Response to

Request for Additional Information No. 378(4409, 4513, 4490), Revision 2, Supplement 7

U. S. EPR Standard Design Certification
AREVA NP Inc.
Docket No. 52-020
SRP Section: 06.02.01 - Containment Functional Design
SRP Section: 06.02.02 - Containment Heat Removal Systems
SRP Section: 06.02.03 - Secondary Containment Functional Design

Figure 06.02.01-87-18 — Temperatures in the Center of the Subdivided Containment Dome at Elevations of +63.98 ft and +71.53 ft

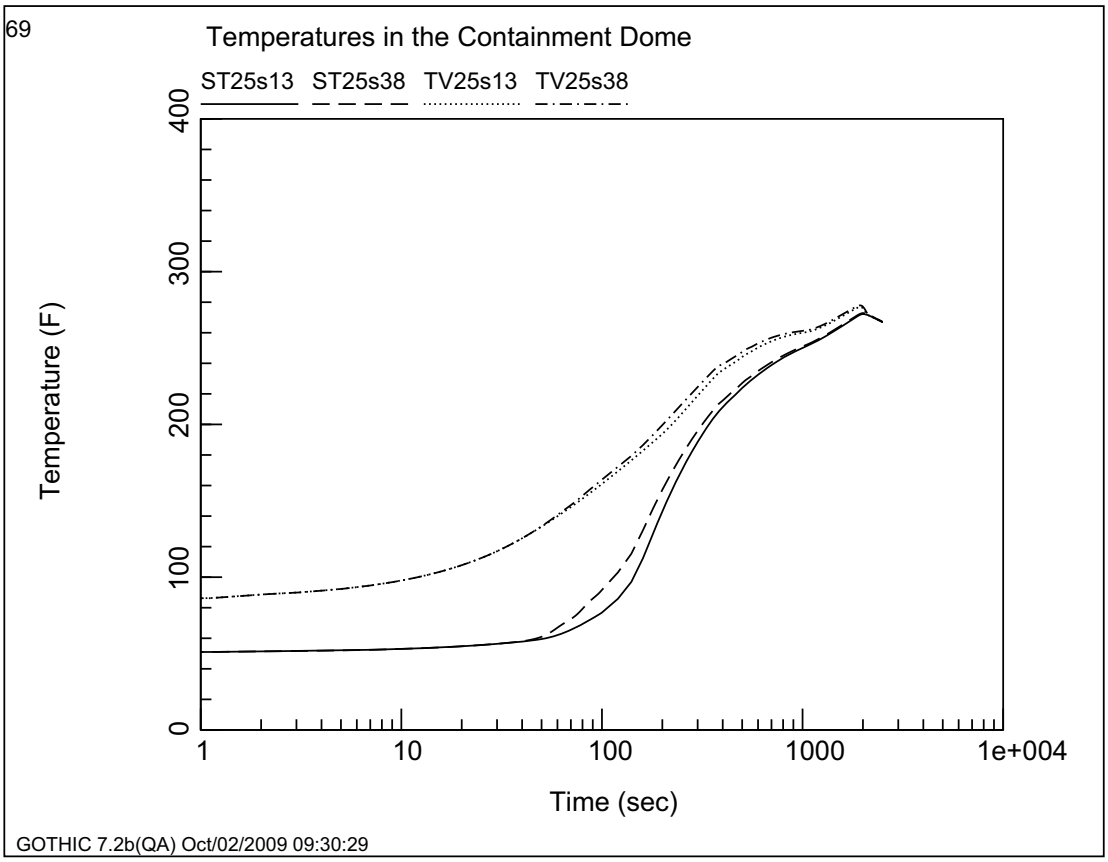
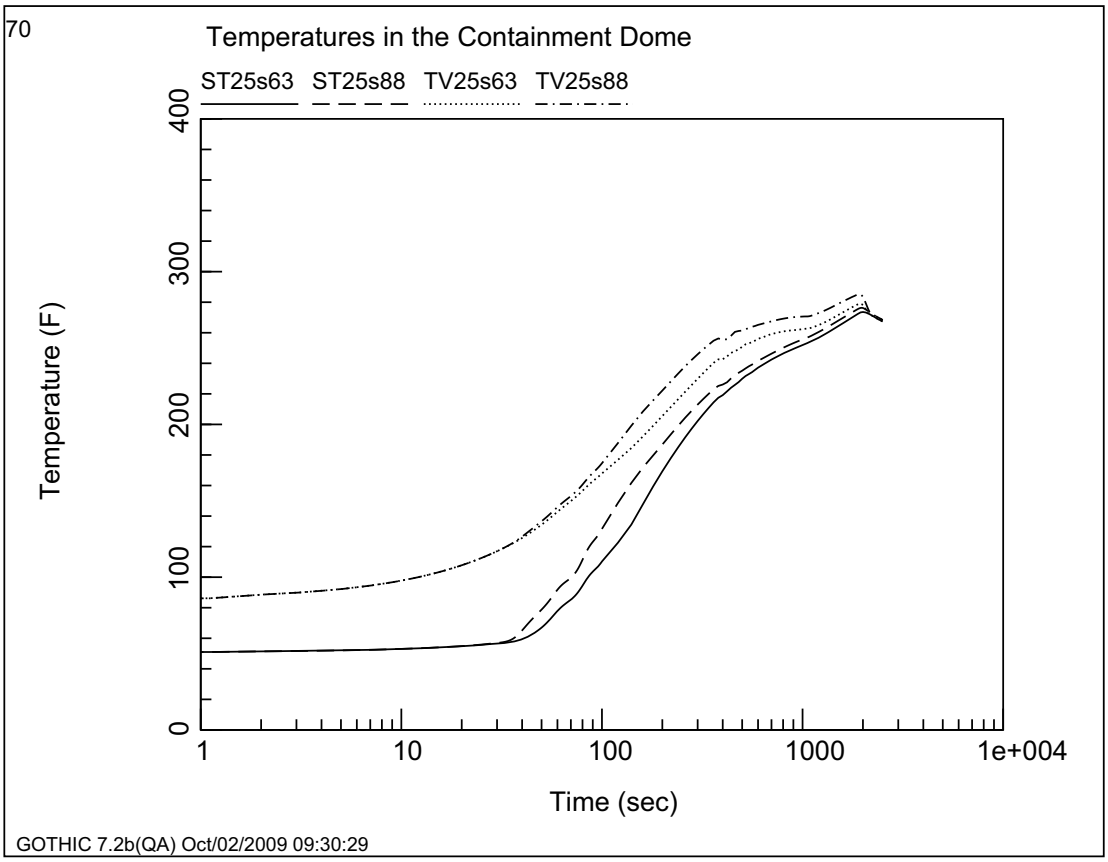
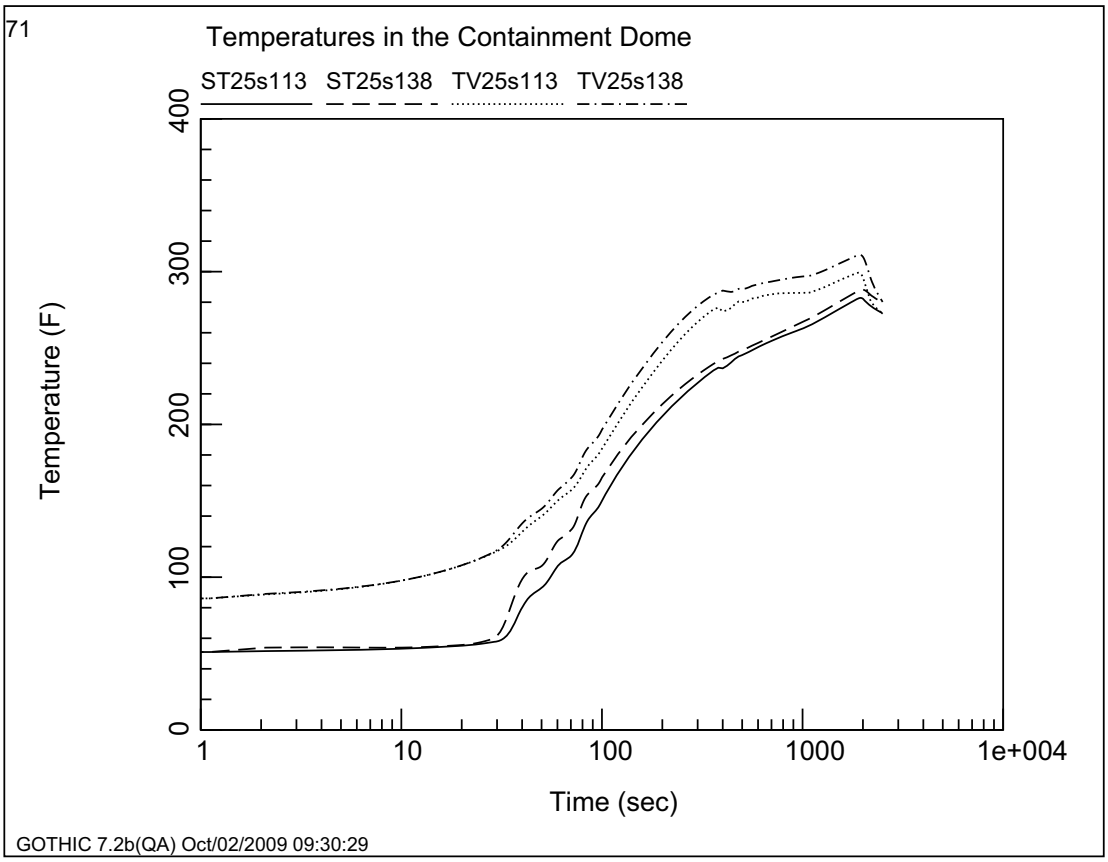
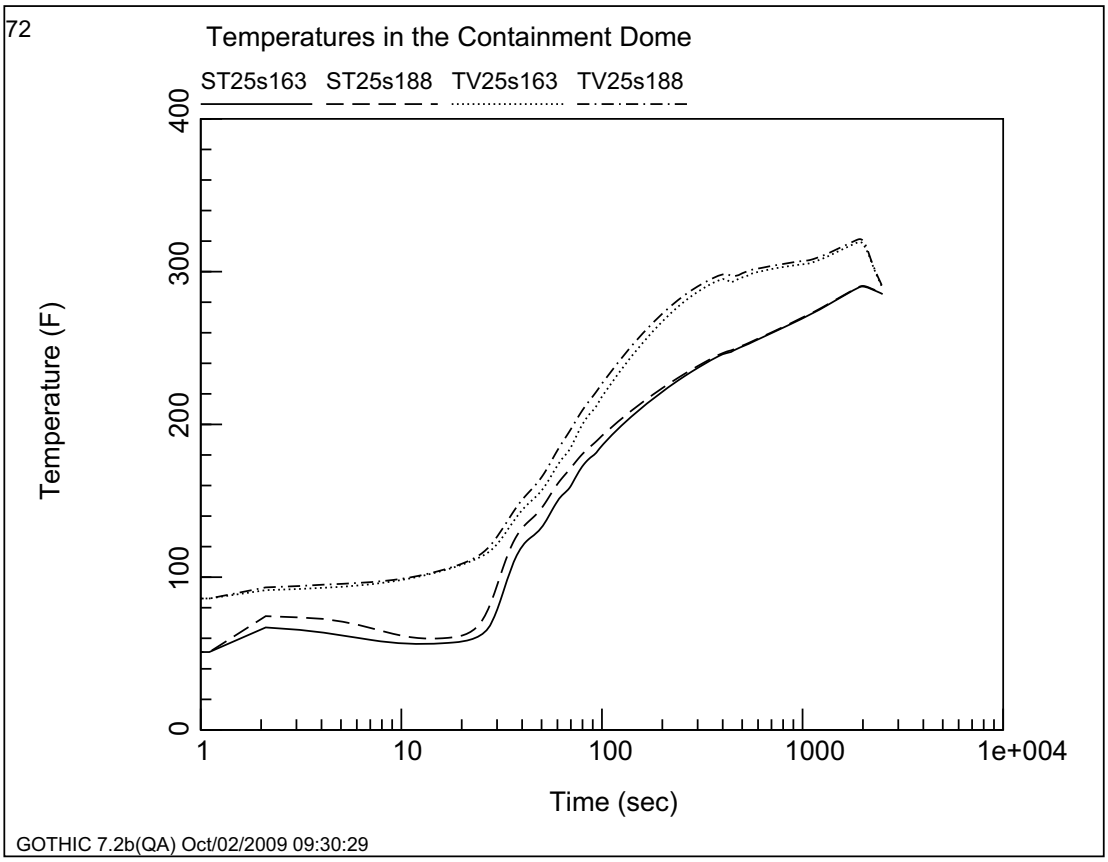
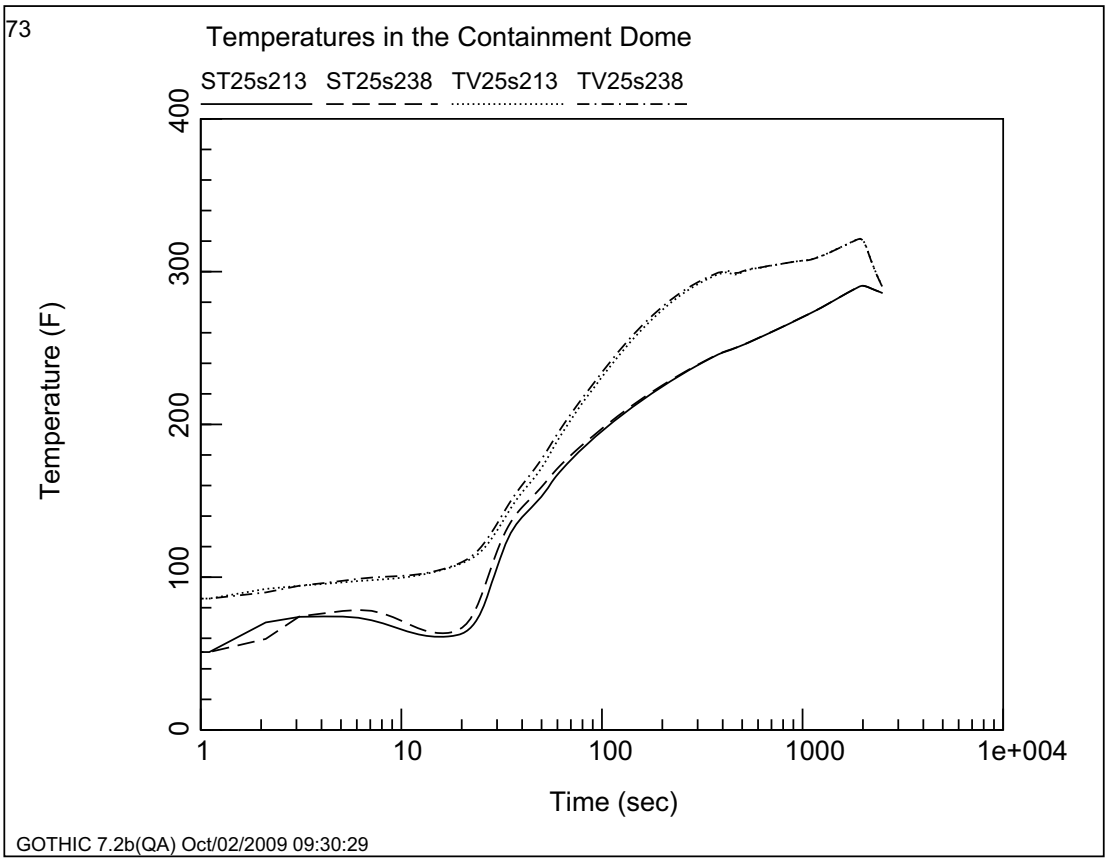
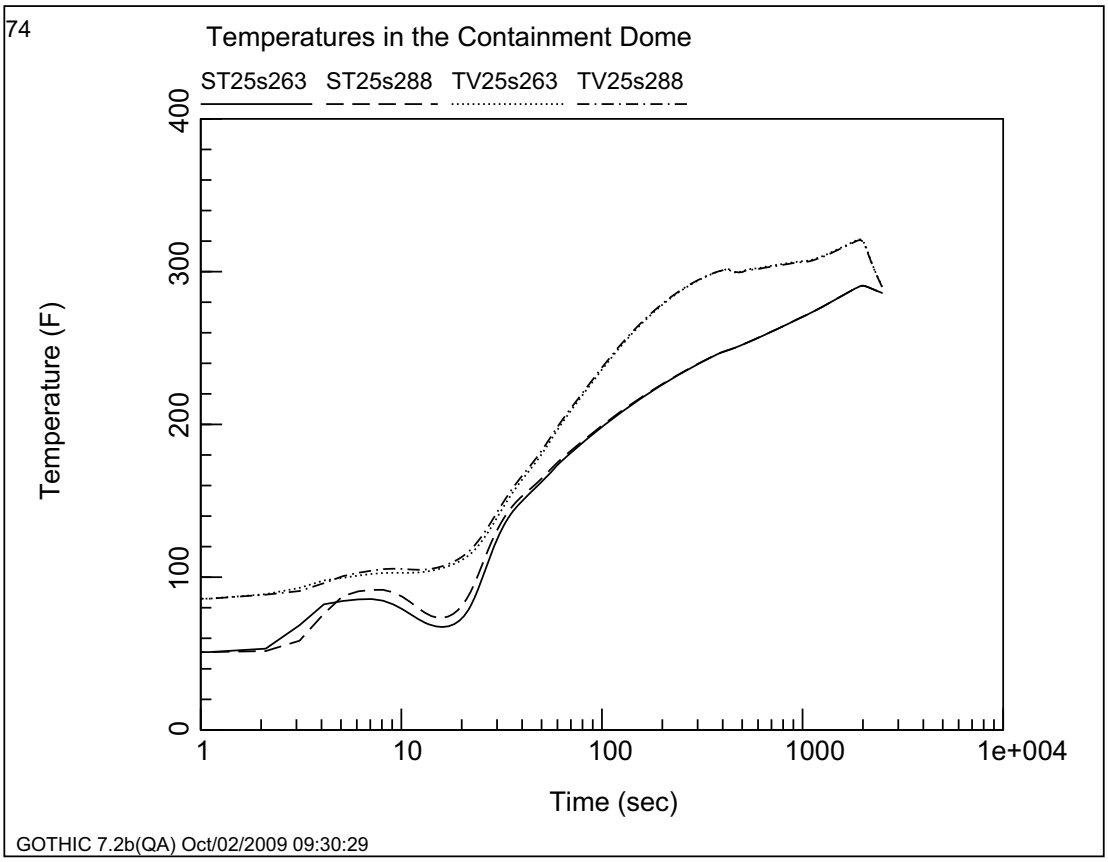
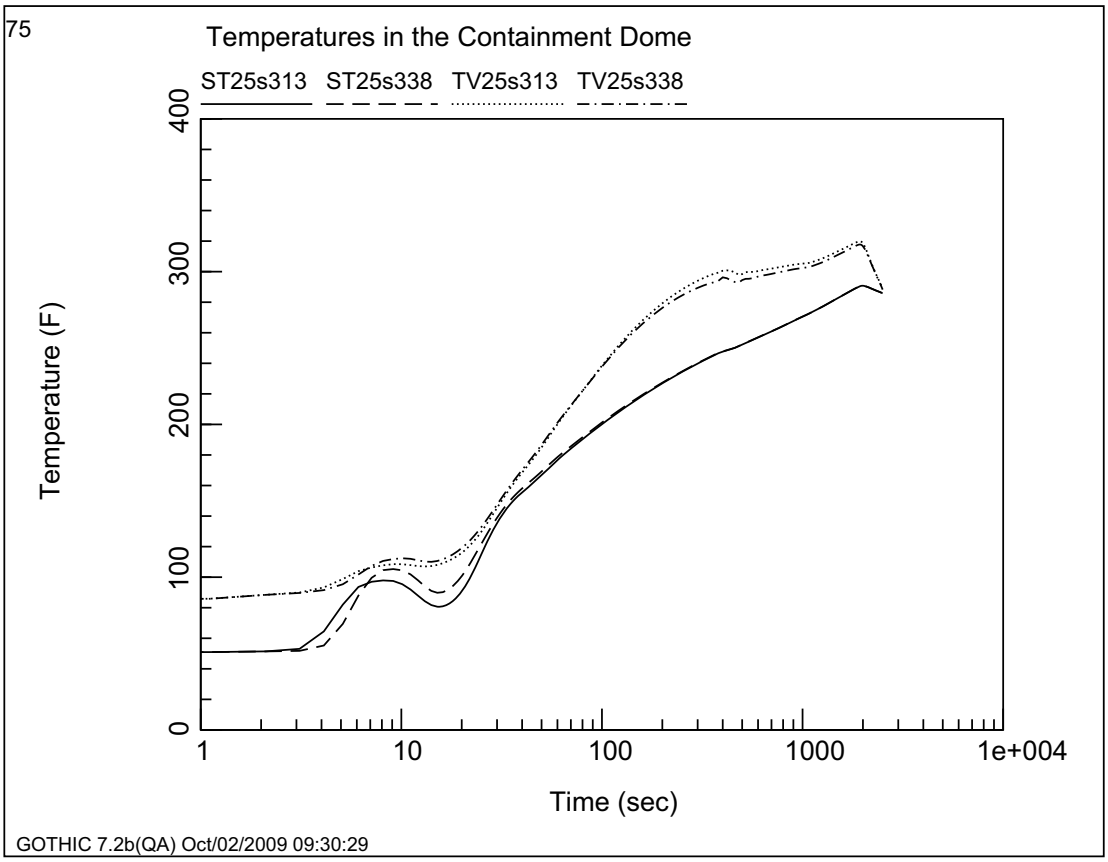
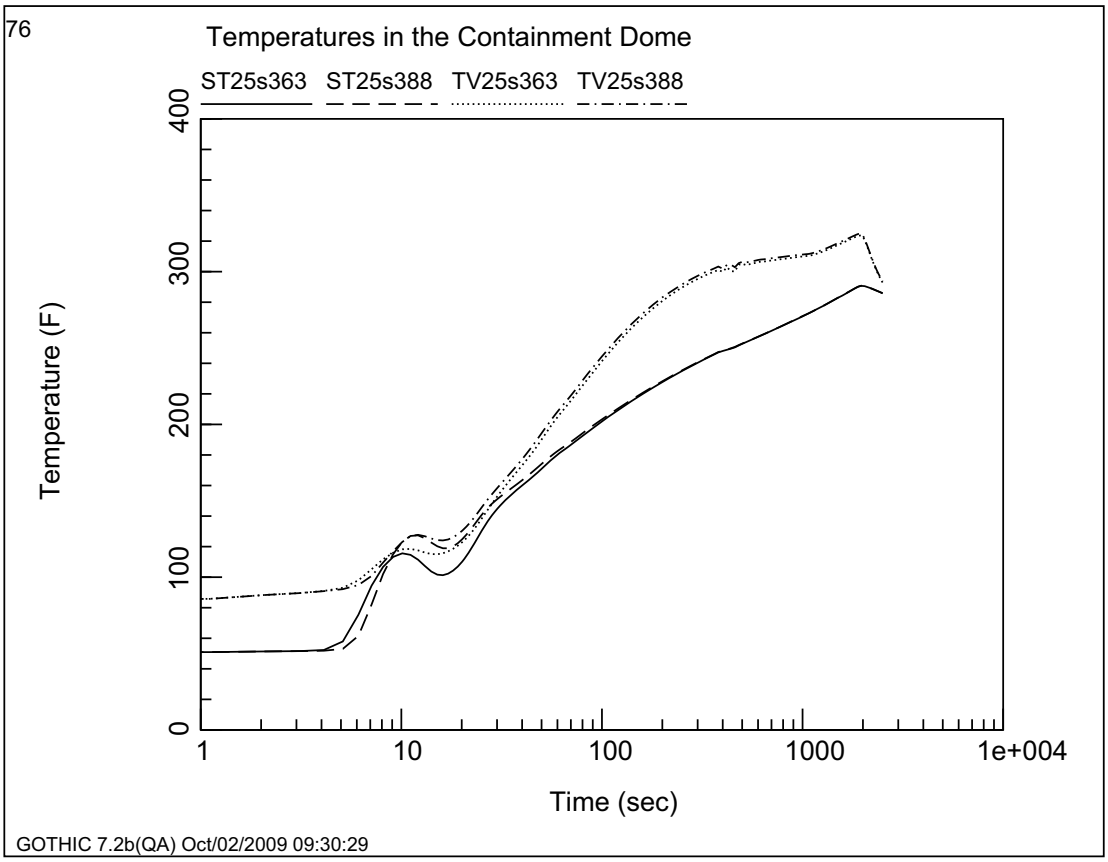
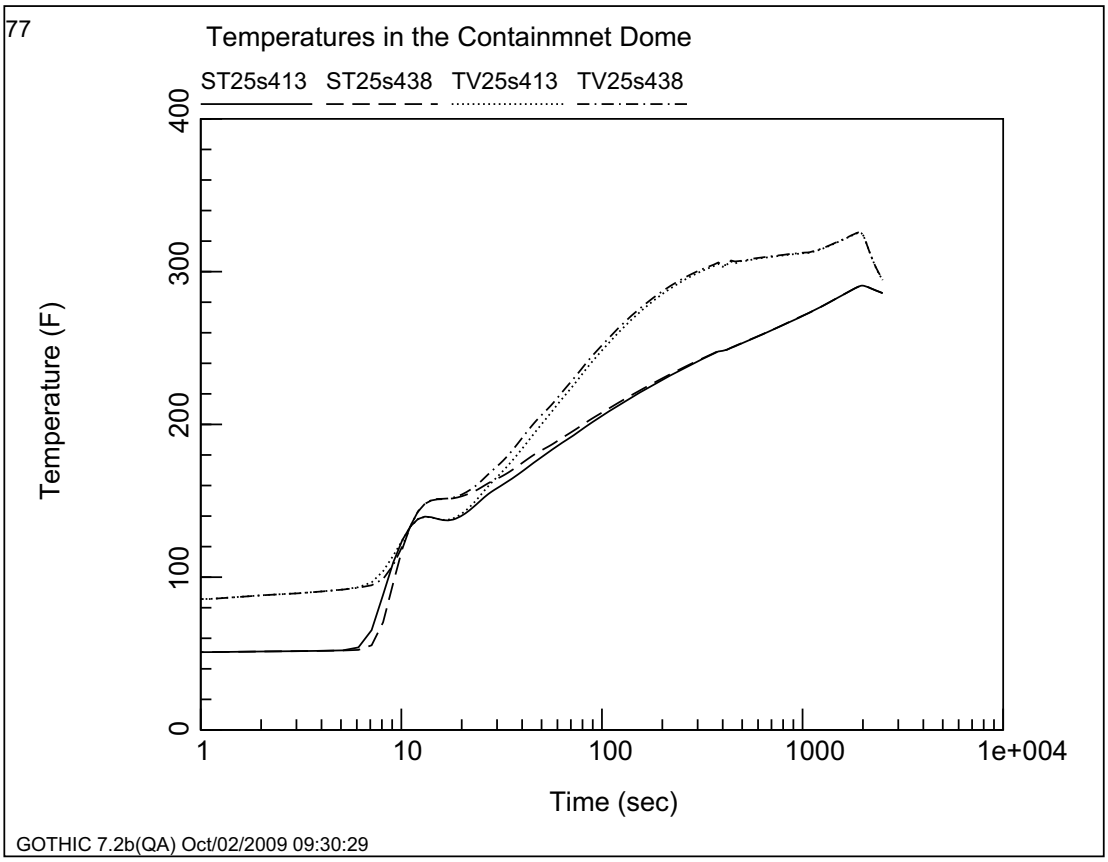
f) Time history atmospheric temperature plots for subdivided nodes in the dome region nearest the containment centerline (19 vertical locations). The atmospheric temperature plots should include both gas (vapor) and saturation temperatures.

f) Figures 06.02.01-87-18 through 06.02.01-87-27 show the time history atmospheric temperature plots for the subdivided nodes nearest the containment centerline.
